# Access Compliance Report

## Public Rights-of-Way

Intersection ID: 52462	Main Street: ST_ANDREWS_HOMES_PL	Cross Street: CENTRAL_AV	Location: NE
ADA ID: 5D04DDE1787B	Ramp Type: Perp	Initial Pass/Fail: Fail	Overall Compliance: No
		Severity Score: 8.75

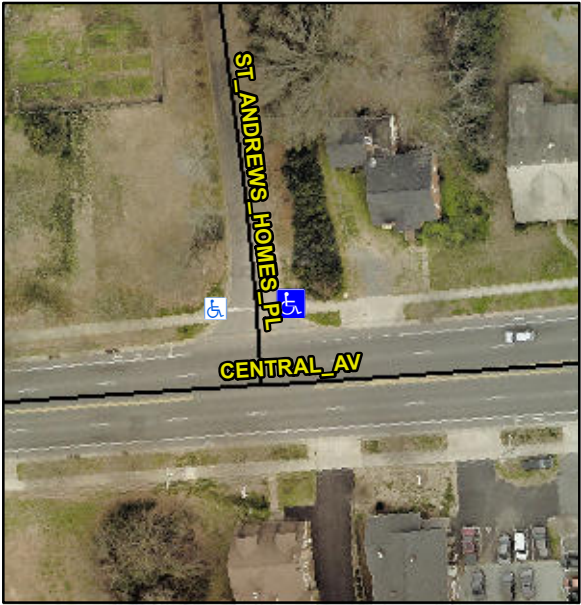
Codes/Mitigation Info/Possible Solution			Field Measurements/Component Compliance		
	Possible Solutions:		<b>Compliance</b>	<b>Description</b>	<b>Data</b>
	<b>Remove &amp; Replace Entire Ramp.</b>		<b>Yes</b>	Ramp Length (in)	83.0
			<b>No</b>	Ramp Width (in)	41.0
			<b>N/A</b>	Flare Type LT	N/A
			<b>N/A</b>	Flare Slope LT (%)	N/A
			<b>N/A</b>	Flare Traversable LT?	N/A
			<b>N/A</b>	Landing Length (in)	N/A
			<b>N/A</b>	Landing Width (in)	N/A
			<b>N/A</b>	Landing Slope (%)	N/A
			<b>N/A</b>	Landing X Slope (%)	N/A
<p>Surveyor Notes:</p> <p><b>N/A</b></p>			<b>N/A</b>	Landing Curb? (Y/N)	N/A
			<b>N/A</b>	Shared Landing?	N/A
			<b>N/A</b>	Gutter Ponding?	N/A
			<b>N/A</b>	Gutter Lip Ht (in)	N/A
			<b>N/A</b>	Painted X Walk1?	No
			<b>N/A</b>	X Walk 1 Direction	To W
			<b>N/A</b>	X Walk 1 Width (in)	N/A
			<b>N/A</b>	X Walk 1 Slope (%)	1.9
			<b>N/A</b>	X Walk 1 X Slope (%)	3.4
			<b>N/A</b>	Ramp inside XWalk1?	N/A

<p>PROW/ADA:</p> <p><b>Not Found, R304.5.1</b></p>			<b>N/A</b>	Road Slope (%)	N/A
			<b>N/A</b>	Road X Slope (%)	N/A
			<b>N/A</b>	Any Obstructions?	N/A
			<b>N/A</b>	Obstruction Type	
			<b>N/A</b>		
			<b>N/A</b>		
			<b>N/A</b>		
			<b>N/A</b>		
			<b>N/A</b>		
			<b>N/A</b>		
<p>Street 1 Name</p> <p>Stop Condition-Street 2</p> <p>Street 2 Name</p> <p>Stop Condition-Street 1</p>	<b>ST ANDREWS HOMES PL</b>		<b>N/A</b>	Clear Space?	N/A
	<b>StopSign</b>		<b>N/A</b>	Clear Space to XWalk (in)	N/A
	<b>N/A</b>		<b>N/A</b>	Storm Grate/Utility Hazard?	N/A
	<b>N/A</b>		<b>N/A</b>	Storm Grate/Utility Type	
			<b>N/A</b>		
			<b>N/A</b>		
			<b>N/A</b>		
			<b>N/A</b>		
			<b>N/A</b>		
			<b>N/A</b>		
Total Cost:		\$ 1850.00			
			<b>Yes</b>	Surface Condition? (G/P)	Good
